SEWAGE DISPOSAL SYSTEM

SUBDIVISION Clarksville Ridge LOT 40 ROAD 11513 Crows Nest Road

REPAIR - PURPOSE - SEPTIC SYSTEM HAS FAILED

RE: Percolation Re-Test
Lot 41
Clarksville Road

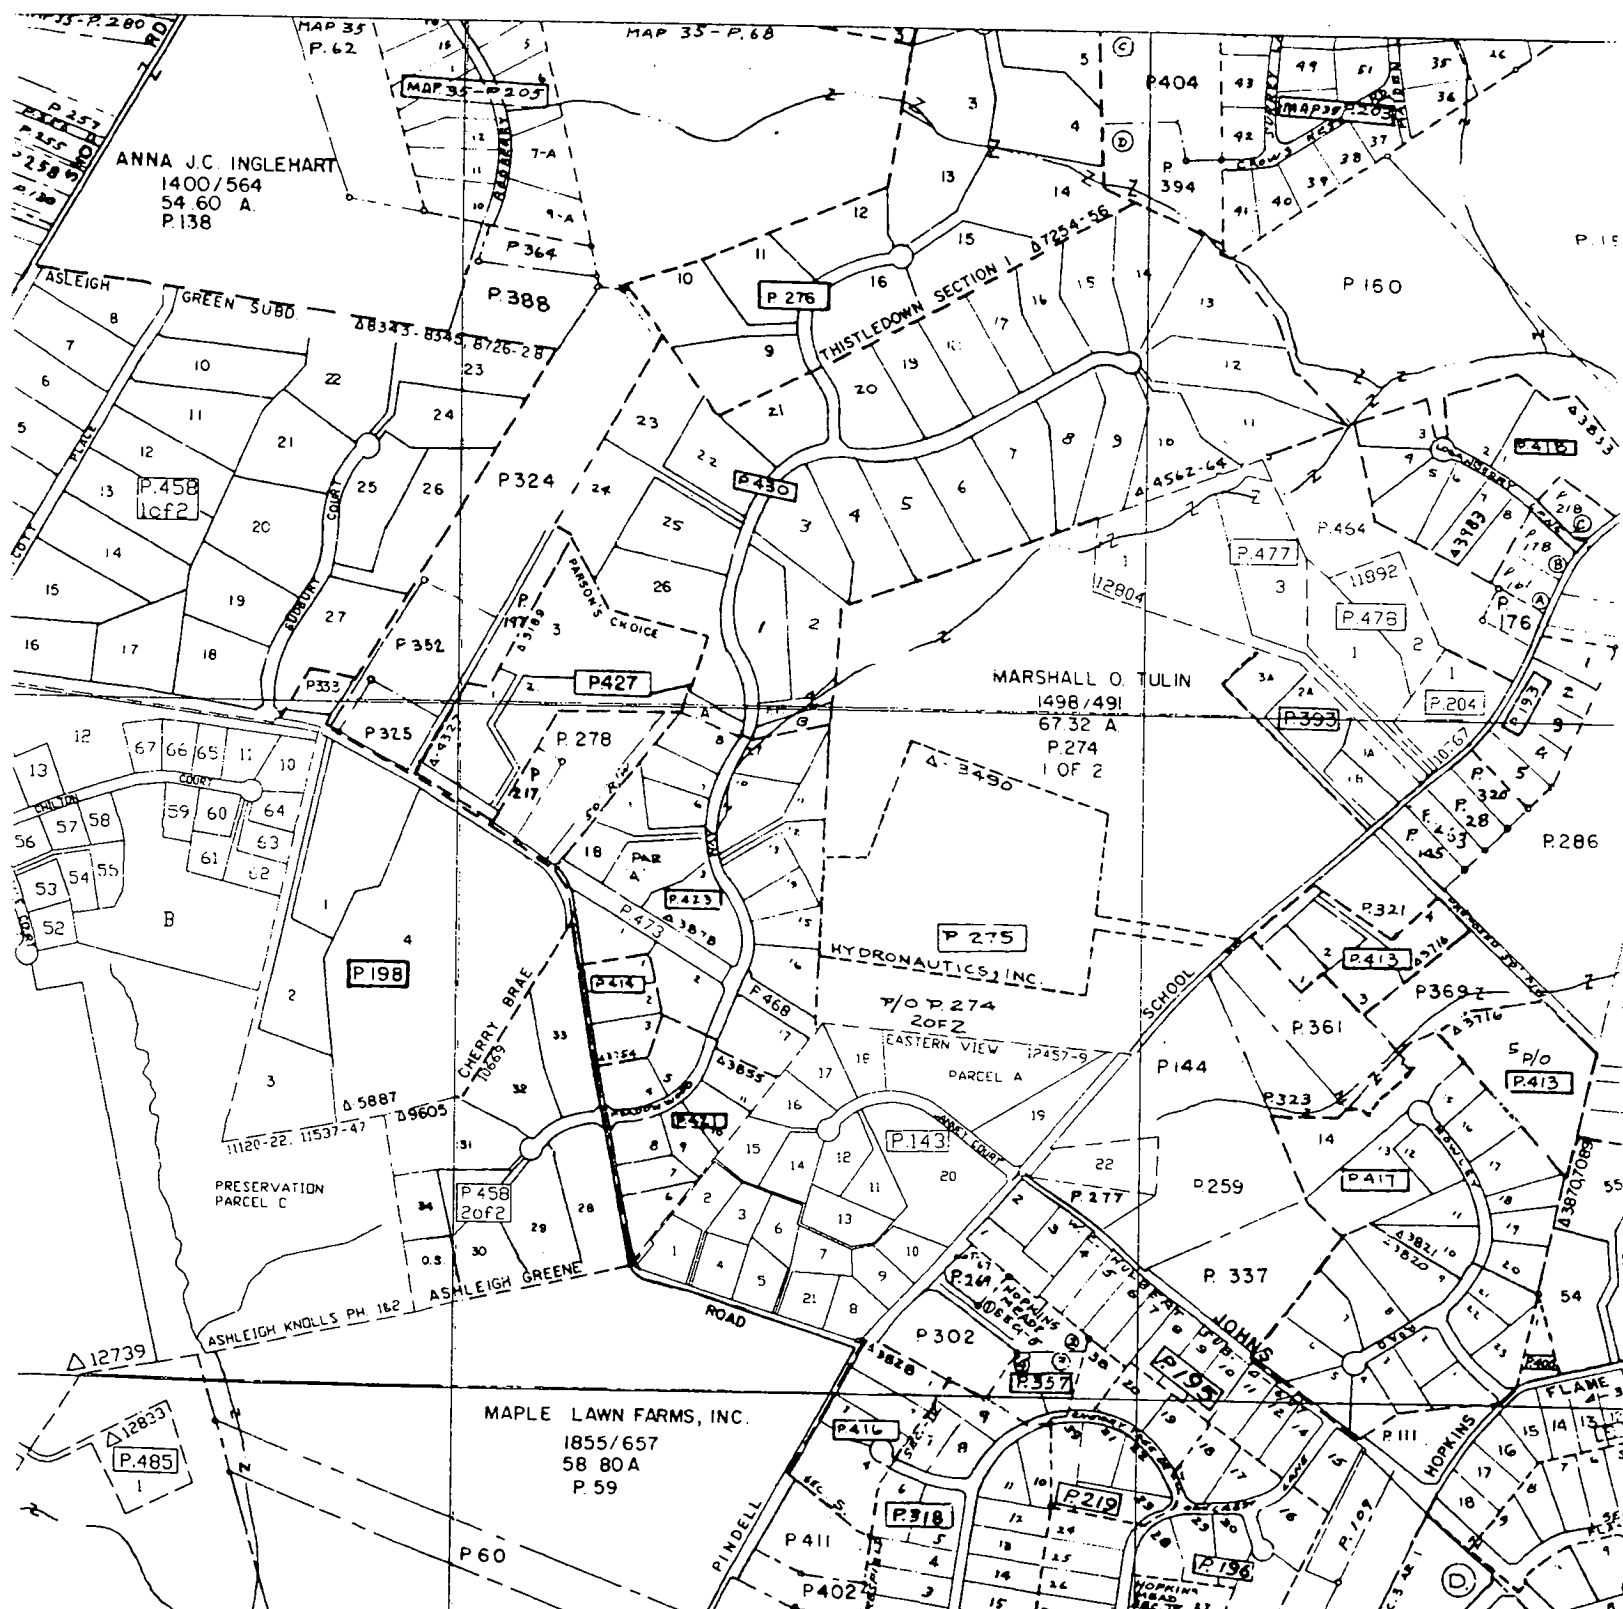
REMARKS: Owner owns both lots - use Perc hole "C" and install a 100' bed as close to the road as possible - Pump syst. needed Au

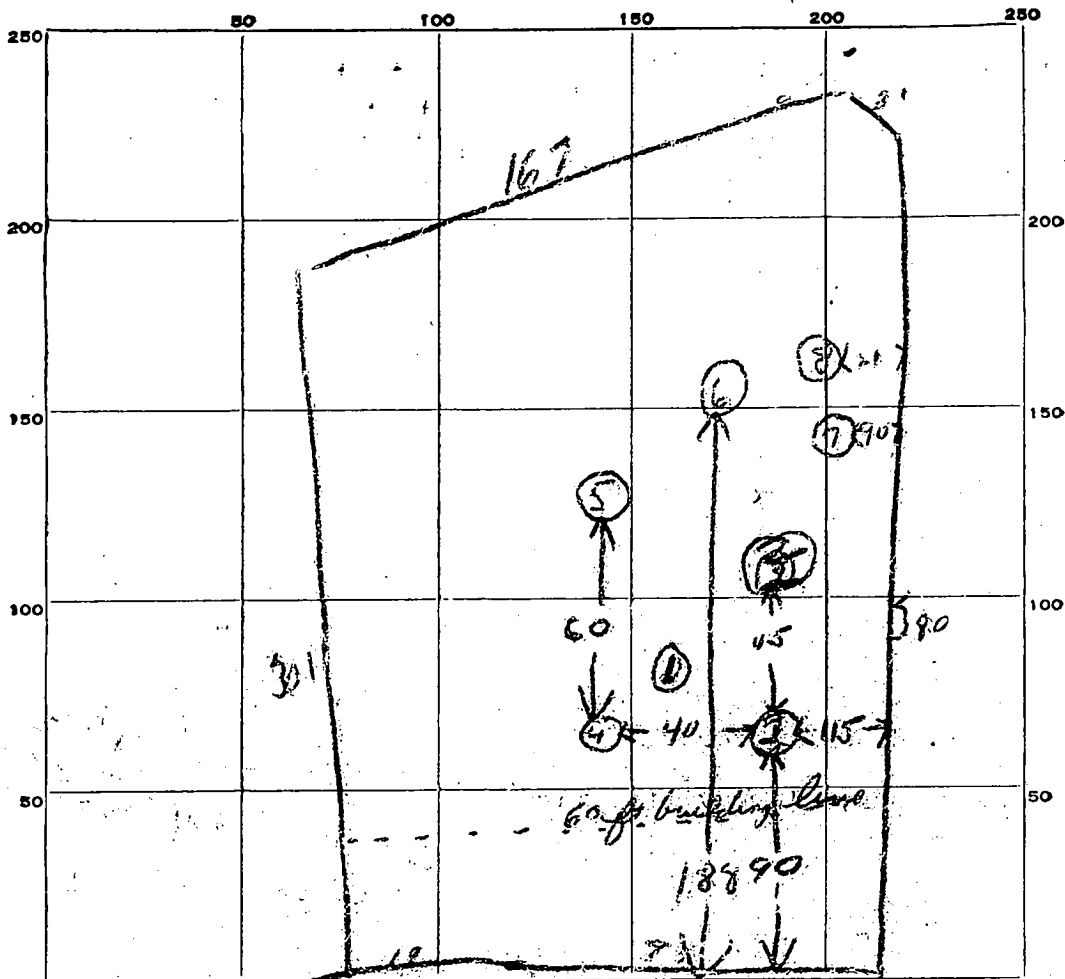
REASONS FOR REJECTION OR HOLDING 7/9/64 - poor soil condition - little perc - one

high water table (5 3/4 ft + 6 3/4 ft)

10/22/85 ORIGINAL REJECTION OF THIS PROPERTY RECONFIRMED.

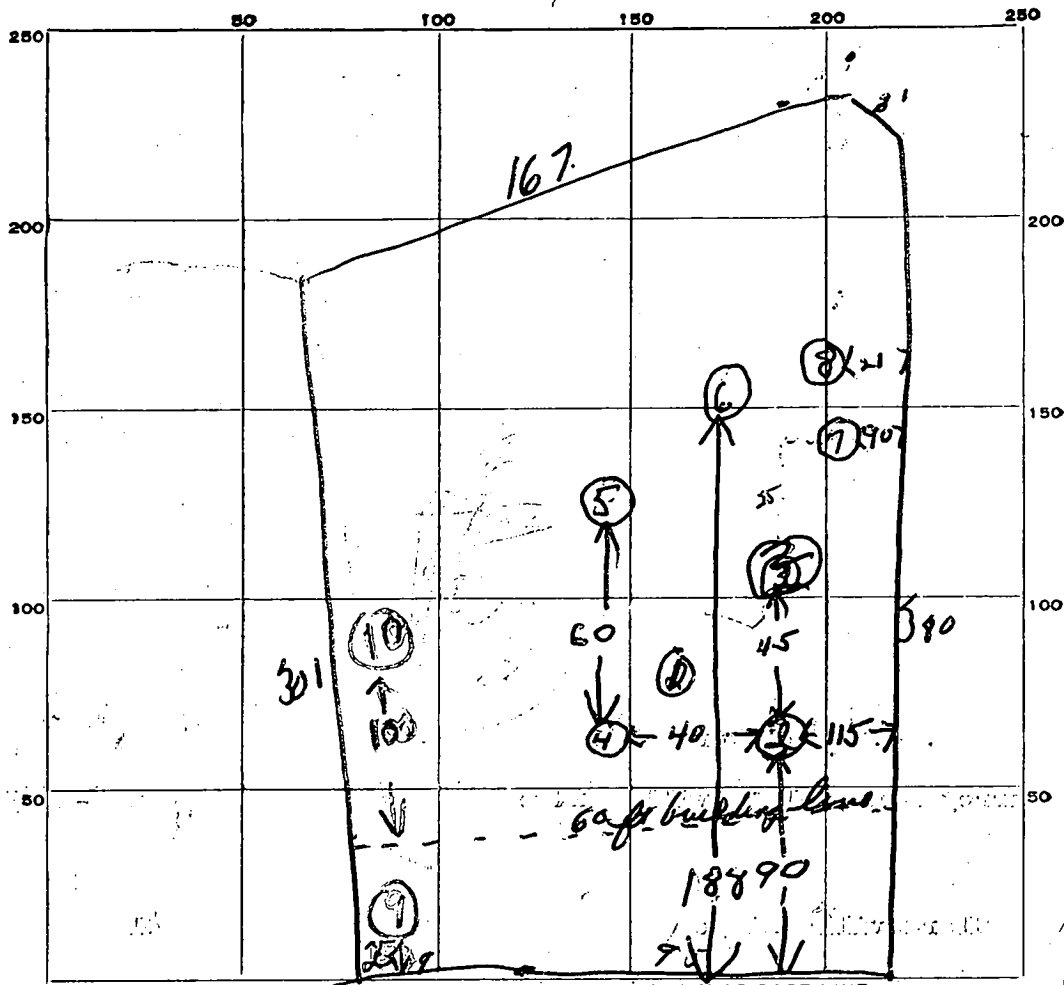
REASONS FOR REJECTION OR HOLDING 7/9/64 - poor soil conditions - little perc - one
high water table (5' up to 6' up)
